DRAFT PROPOSAL FOR AMENDMENTS TO REGULATION No. 50

(Rear-registration plate illuminating devices)

Transmitted by the expert from Japan

Reference Figure

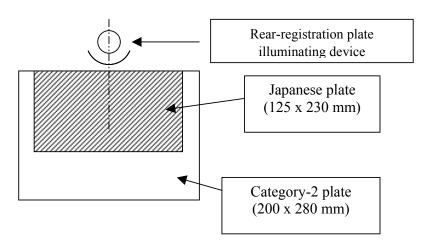
- * Under R50, two sizes of the plates for measuring the luminance of rear-registration-plate illuminating devices may be used: category 1 (130 x 240 mm) and category 2 (200 x 280 mm). Under the Japanese regulation, the plate size is required to be 125 x 230 mm, which is smaller than category 1 of R50, and the devices approved under R50 by using the category-1 plate do not conform to the Japanese photometric requirements at all. Nevertheless, the devices approved under R50 by using the category-2 plate can satisfy most of the Japanese photometric requirements if the upper edge of the Japanese plate is placed over the upper edge of the approved plate location (see Figure).

- * In other words, the photometric requirements of R50 will become almost equivalent to those of the Japanese regulation if the current provision allowing for the use of either category 1 or category 2 in applying for approvals is amended to designate the use of category 2 for motorcycles. Japan intends to adopt R50 if the above amendment is made.

The devices ean be of category 1 or 2 shall be of category 2 for motorcycles and of category 1 or 2 for mopeds. The devices of category $\frac{2}{3}I$ shall be designed to illuminate a space of at least 130 x 240mm, the devices of category 2 a space of at least 200 x 280 mm."
